**Homegoods Entry Renovation, JSP13-66**

Consideration of the request of Woods Construction Inc. for Preliminary Site Plan and Section 9 Façade Waiver. The subject property is located in Section 15 at 43635 West Oaks Drive in the RC, Regional Center District. The applicant is proposing to modify the entrance to the existing Homegoods store.

FACADE REVIEW

Re: FACADE ORDINANCE – Final Site Plan Review  
**Home Goods Entry Renovation, PSP13-01462**  
 Façade Region: 1, Zoning District: RC, Building Size: 30,000 S.F.

Existing Home Goods Entrance Portico

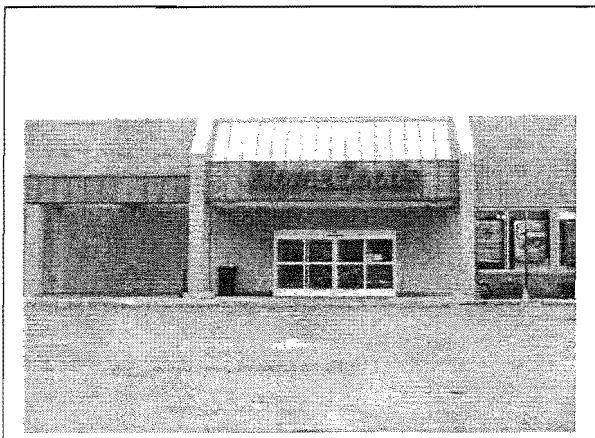
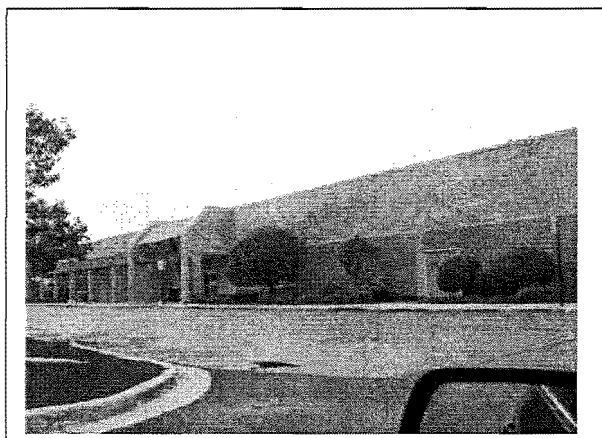
As shown above the minimum percentage of Natural Clay Brick is not provided and the proposed percentage of Thin Brick exceeds the maximum amount allowed by the Façade Chart. The percentages of existing Scored CMU and Fluted CMU, which are proposed to be painted, also exceed the maximum amounts allowed by the Façade Chart. These deviations from the Façade Ordinance would require a Section 9 Waiver.

Field inspection of the project site indicates that several of the storefronts in the shopping center have recently been renovated using red colored natural clay brick and other materials that are consistent with the Façade Ordinance. Only one other storefront within the same shopping center, located directly east of the subject storefront, is constructed of natural colored fluted and scored CMU similar to the subject façade. This combination of non-harmonious materials and colors detracts from the overall appearance of the shopping center.

**Recommendation** – The proposed alteration generally represents an improvement in the existing façade that, to some extent, will increase compatibility with adjacent buildings. A Section 9 Waiver is therefore recommended for the underage of Natural Clay Brick and overage of Thin Brick and painted CMU. This recommendation is contingent upon the applicant providing a sample board indicating carefully coordinated colors that are harmonious with adjacent buildings at least 5 days prior to the Planning Commission meeting.

It is strongly recommended that in lieu of painting portions of the façade, the applicant consider re-facing that area with a continuation of the materials introduced on the entrance portico (Thin Brick). This would achieve a significantly greater degree of compatibility with adjacent buildings and enhance the appearance of the overall shopping center.

During the Community Development review process, the question of continuing the panel brick along the remaining portion of the façade came up. We communicated with John Cox, the Vice President of Construction and Fixtures for TJX. He replied that they "simply do not have the dollars in the budget to do this work...we will either do what is on the submitted plan, or we will leave the storefront as it is until our lease is up."

As a clarification, the budget does include painting the existing masonry storefront to match the brick color as closely as possible. Those paint colors have been included in our samples submitted.
